SUBJECT: Transmittal of Class 1 Permit Modification Request to Remove a Refrigeration Unit from Technical Area 50, Building 69

Class 1 Permit Modification Request to Remove a Refrigeration Unit from Technical Area 50, Building 69

Document: Class 1 Modification Remove TA-50-69 Refrigeration
Unit
Date: October 2017

Figure G.4-1
 Technical Area 50, Building 69, Room 102 Container Storage/Treatment Unit Sampling Grid and Additional Sampling Locations

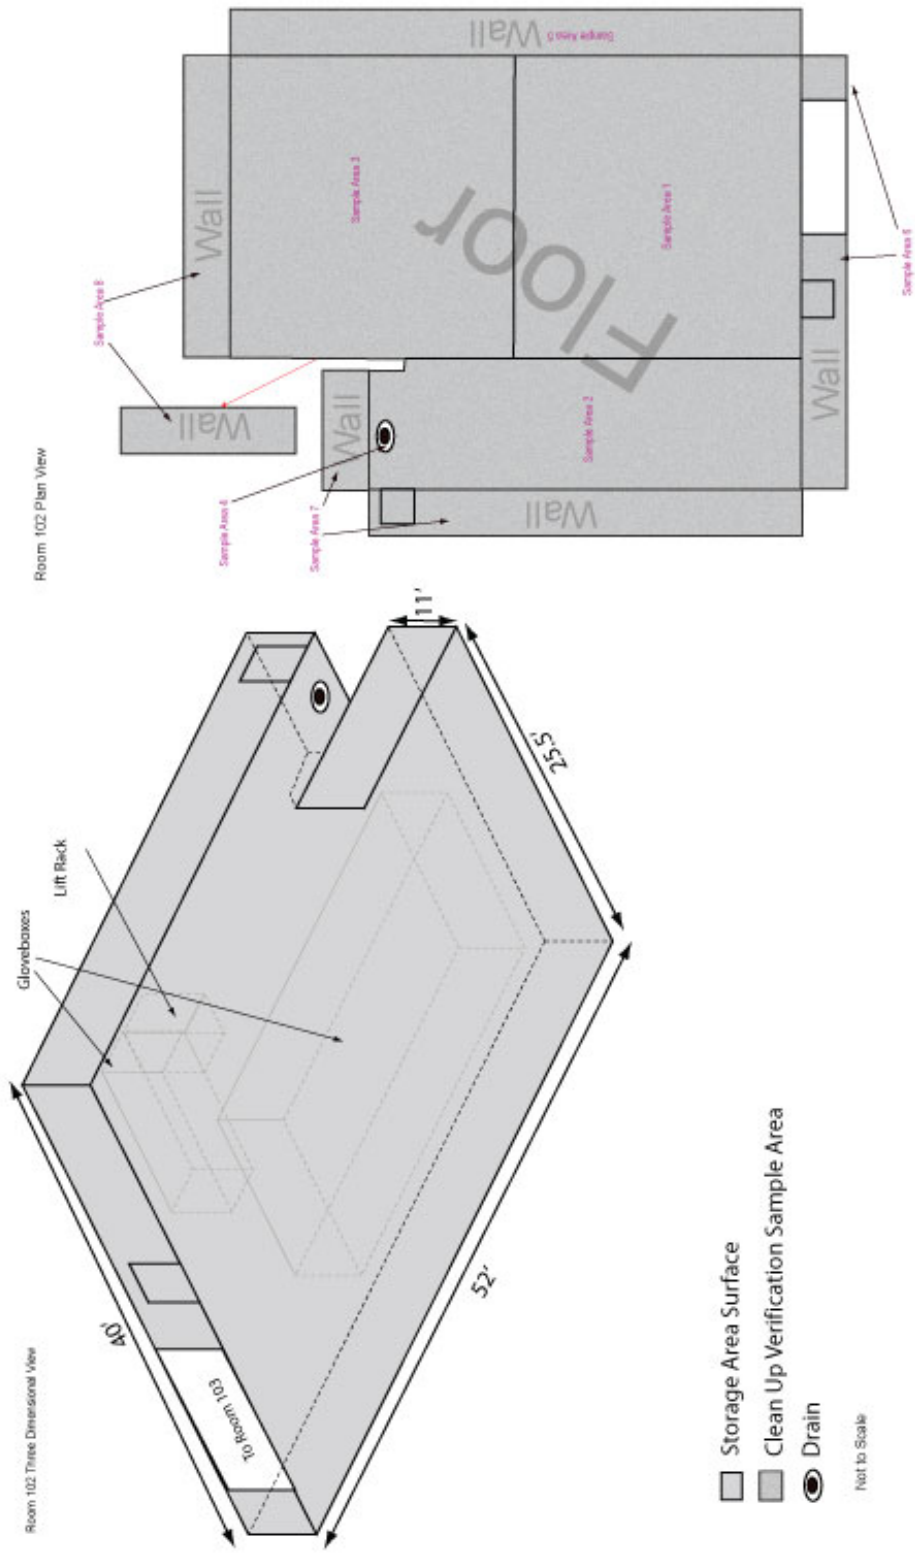
Proposed changes to the closure plan include changing the description of the refrigeration unit within Section 2.0, *Description of Unit to be Closed*, to past tense. Additionally, the refrigeration unit footprint has been removed from Figure G.4.1: *Technical Area 50, Building 69, Room 102 Container Storage/Treatment Unit Sampling Grid and Additional Sampling Locations*.

Figure 23
 Technical Area (TA) 50, Building 69, Indoor Storage/Treatment Unit and Outdoor Container Storage Unit

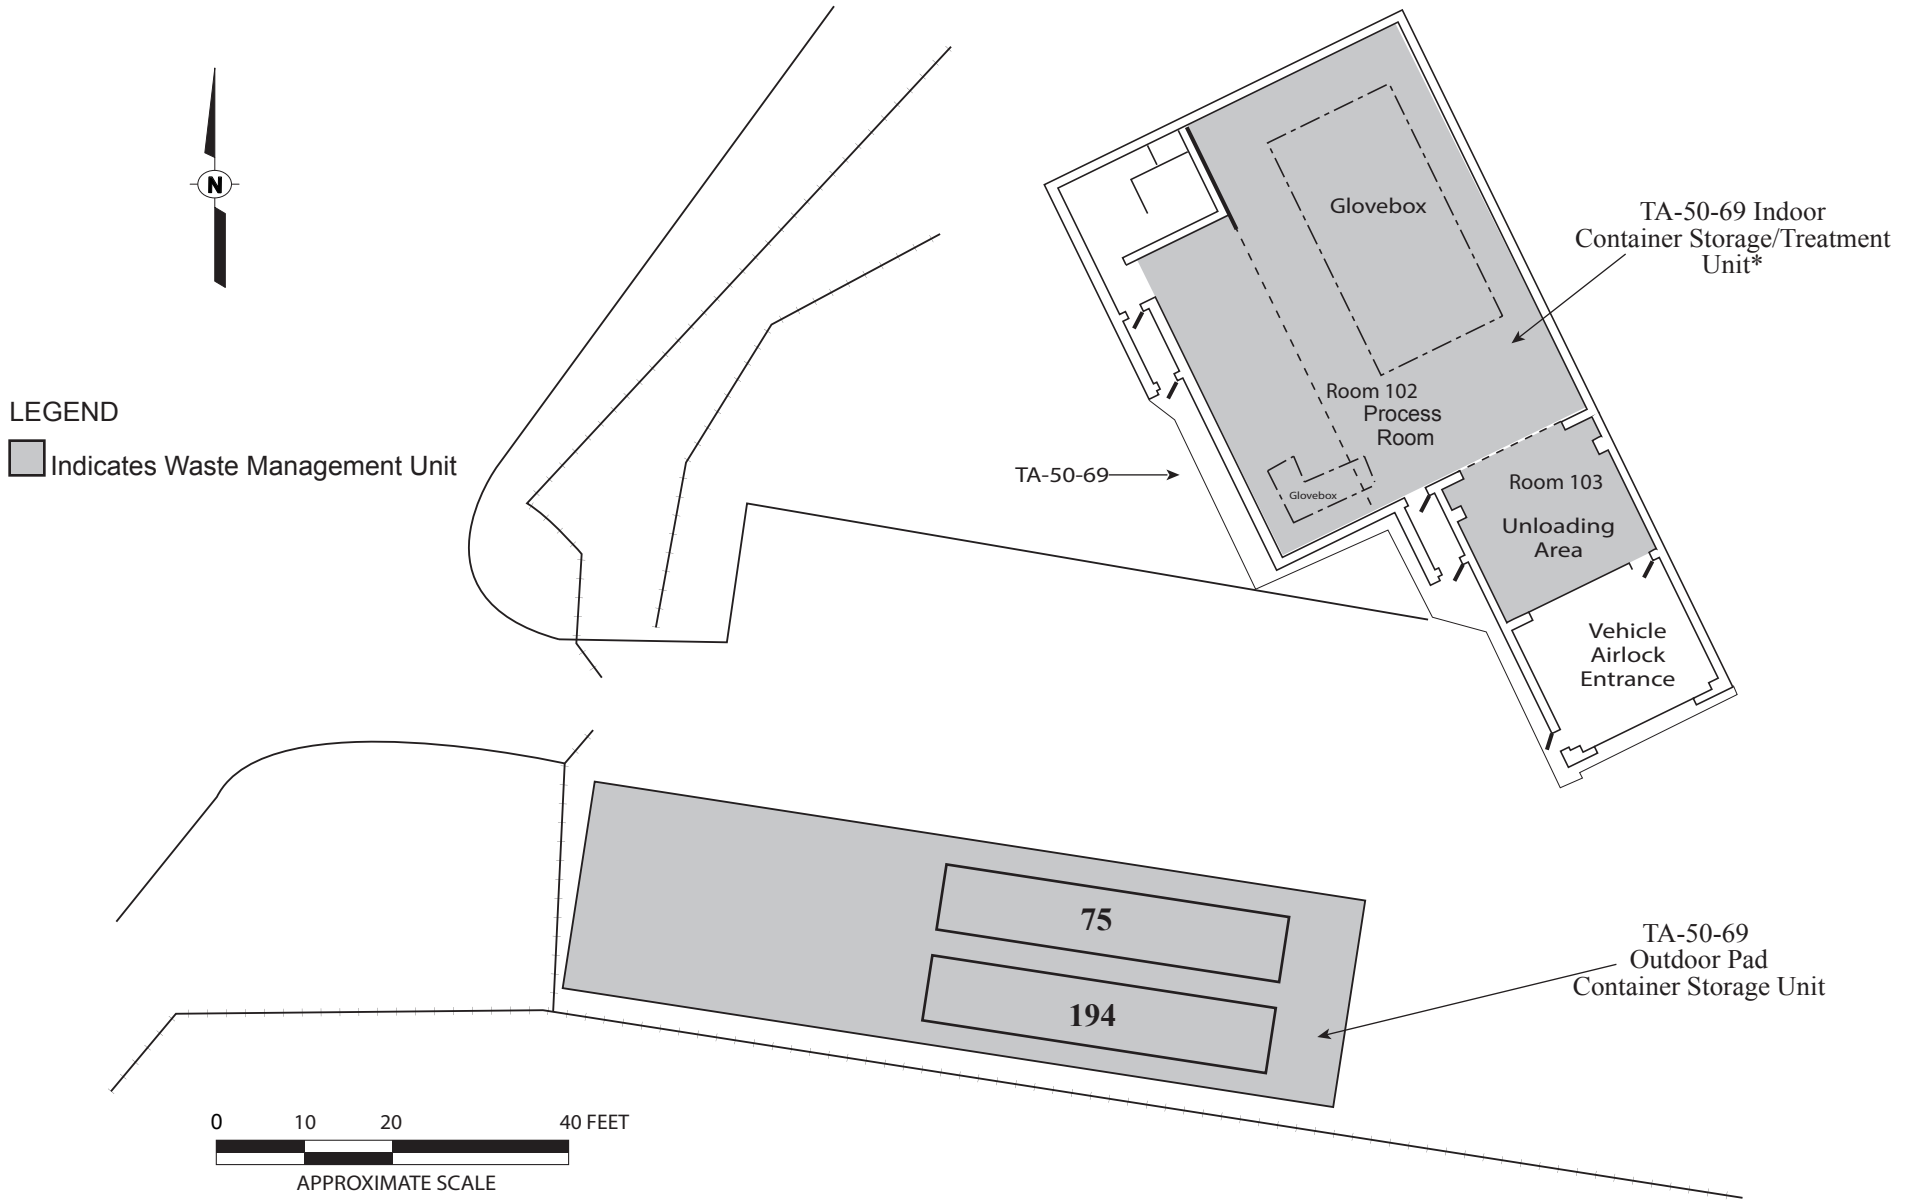
Figure 23: *Technical Area (TA) 50, Building 69, Indoor Storage/Treatment Unit and Outdoor Container Storage Unit*, was revised to remove the refrigeration unit.
